9.3 Process Auxiliaries

The information in this section of the reference ABWR DCD, including all subsections, tables, and figures, is incorporated by reference with the following departures and supplements.

STD DEP Admin

Figure 9.3-10 Breathing Air System Flow Diagram

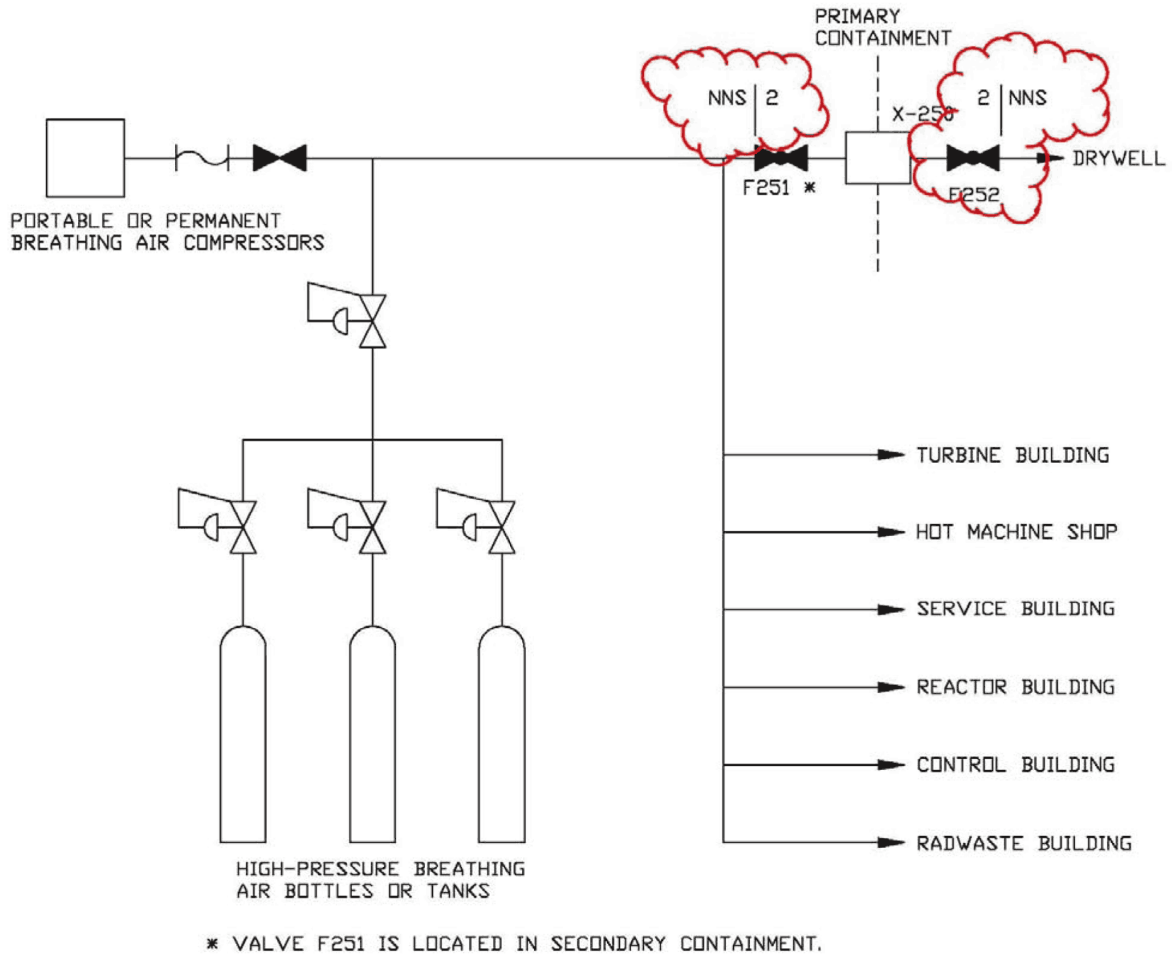
The SAS provides compressed air for tank sparging, filter/demineralizer backwashing, air-operated tools and other services requiring air of lower quality than that provided by the IAS. ~~Breathing air requirements are provided by the SAS.~~ The Breathing Air System (BAS) is discussed in Subsection 9.3.7.6.

9.3.7.6.2 System Description

The BAS is designed to provide compressed air of suitable breathing quality for nonsafety-related functions.

The BAS provides a continuous supply of low pressure breathing air for protection against airborne contamination while performing maintenance inspection and cleaning work. The BAS also provides a means for charging high pressure self-contained breathing apparatus.

The BAS is sized to provide 100% of the peak air consumption using the bottled breathing air supply and a portable permanent breathing air compressor supply system, as needed. The compressor(s) will be of the oil-less, breathing air type.

<u>Pressure (design of BAS)</u>	<u>689 kPaG</u>
<u>Pressure (design of self-contained breathing apparatus charging)</u>	<u>17.23 MPaG</u>
<u>ANSI Compressed Gas Association (CGA) 7.1-1997, "Commodity Specification for Air"</u>	<u>Air Quality Grade D</u>

Figure 9.3-12 Non-Radioactive Drainage System

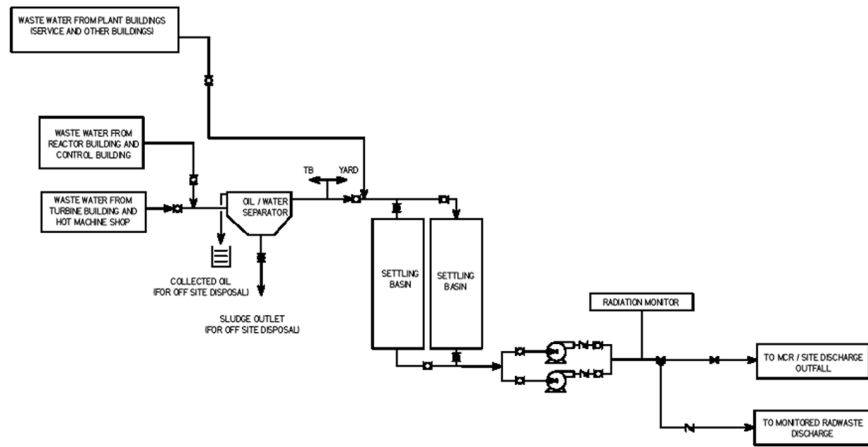
The design of the continuation of the non-radioactive drain system from the ABWR Standard Plant Buildings to the site discharge outfall is provided in Figure 9.3-12 and is discussed in this subsection.

The conceptual design information in this subsection of the reference ABWR DCD is replaced with the following site-specific supplement.

The non-radioactive drain system collects waste water from plant buildings (Reactor, Turbine, Control, Service, and other buildings). A system composed of collection piping, curbs, and pumps is provided. Non-radioactive waste water from the Turbine Building, Reactor Building, hot machine shop and the Control Building is routed to a dedicated oil/water separator where oil and settled solids are removed for off-site disposal. The non-oily, non-radioactive effluent is sent to dual settling basins. Non-radioactive waste water from the Service Building and other buildings is sent directly to the dual settling basins. Means are provided to perform any required tests or analyses required by the discharge permit. The non-radioactive liquid effluent is

discharged to the Main Cooling Reservoir through permitted outfall(s). If radioactivity levels exceed the limits for discharge, the flow from the non-radioactive drains has the capability to be diverted to the radioactive effluent portion of the radwaste system. Normally, if low levels of radioactivity are detected, it is quantified and discharged via the normal outfall. Higher levels of radioactivity may require a permitted "batch" discharge via the radwaste effluent radiation monitor. The non-radioactive drainage system is illustrated in Figure 9.3-12.
